# 5969 Fernbank Road

TIA Strategy Report, Revision 2

September 19, 2018

476654 - 01000

Warrants

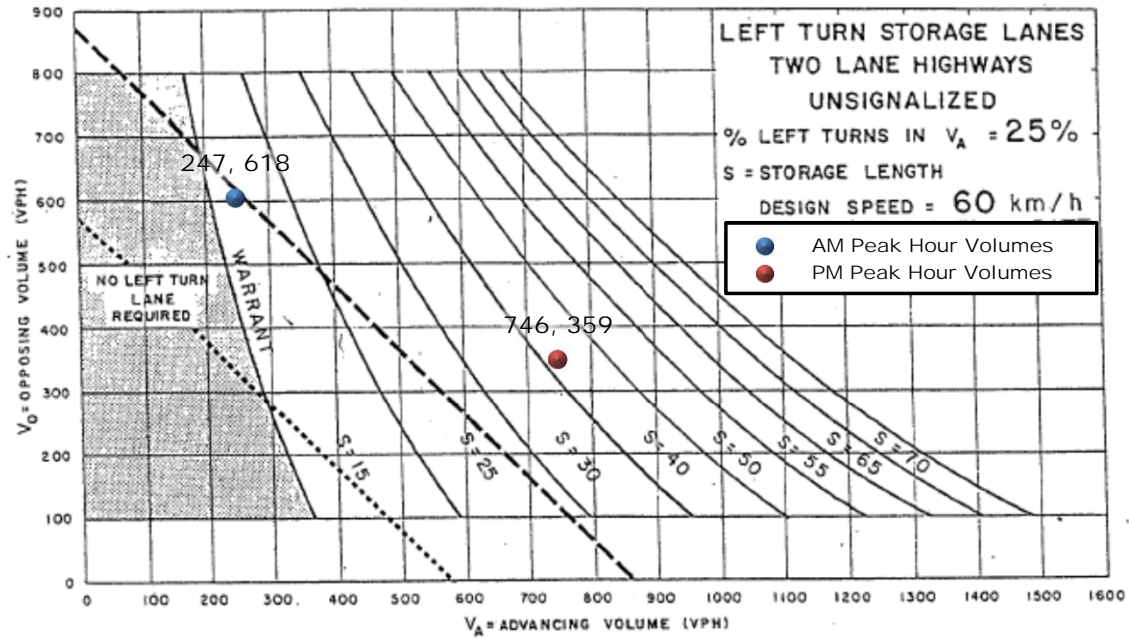
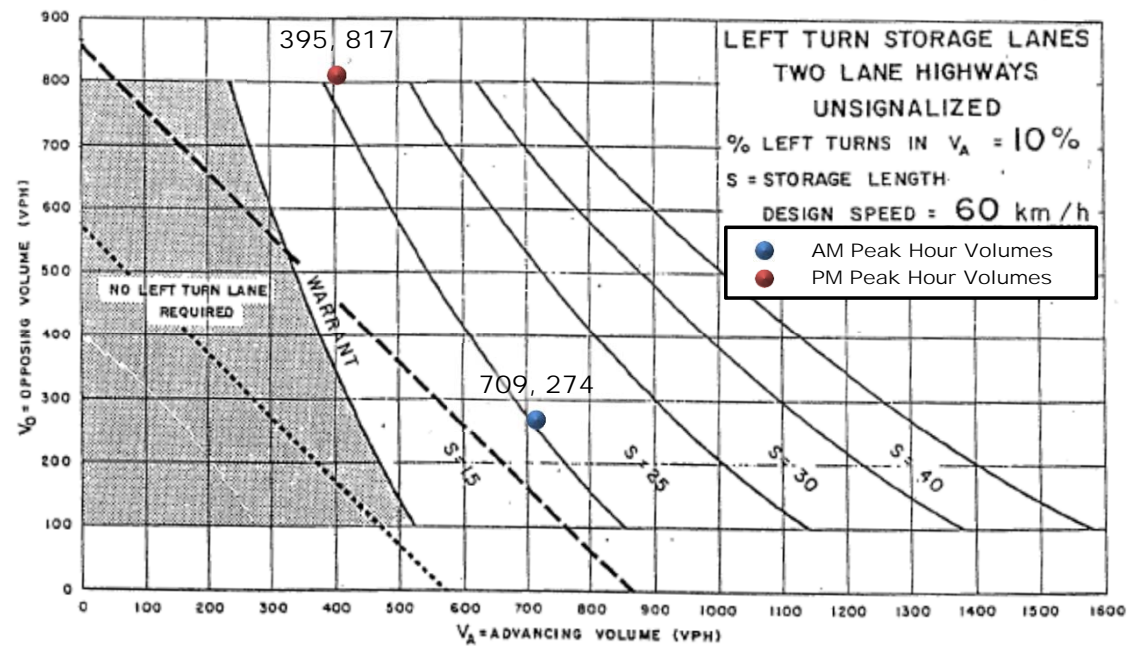
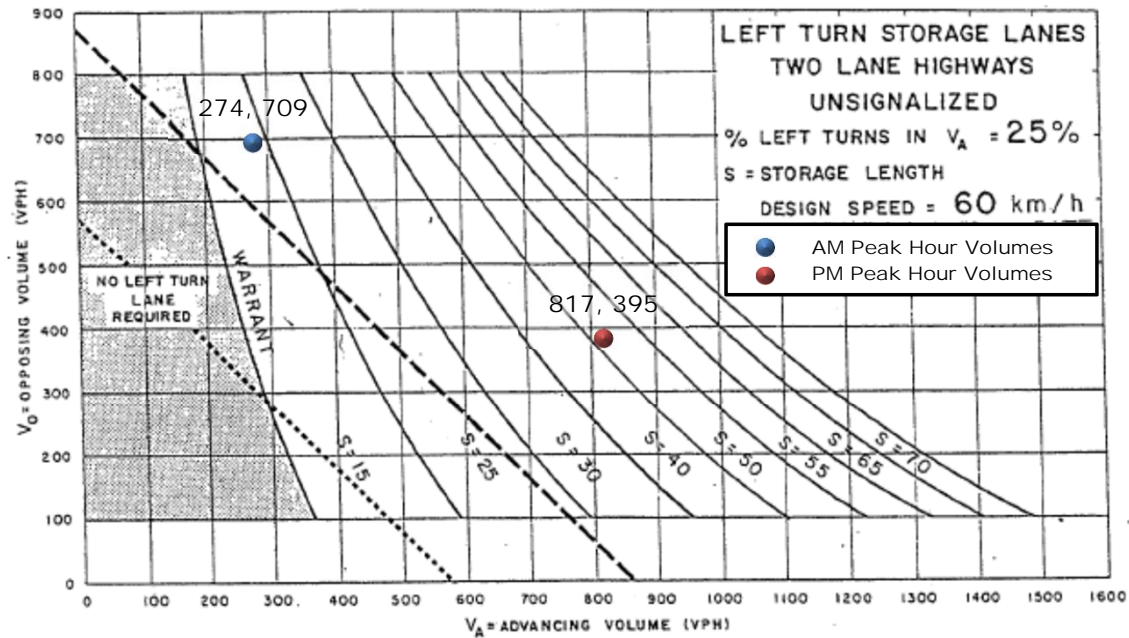
**Comment 14:** *Clarify the MTO warrant sheets in Appendix G for Fernbank/Street 1 intersection. The preference is to provide a roundabout rather than a traffic signal. Confirm funding for the new intersection requirements with Ann Selfe.*

**Response 14:** The warrants used in Appendix G for the Fernbank/Street 1 in are based on methodology outlined in the OTM Book 12, Justification 7 – Projected Volumes.
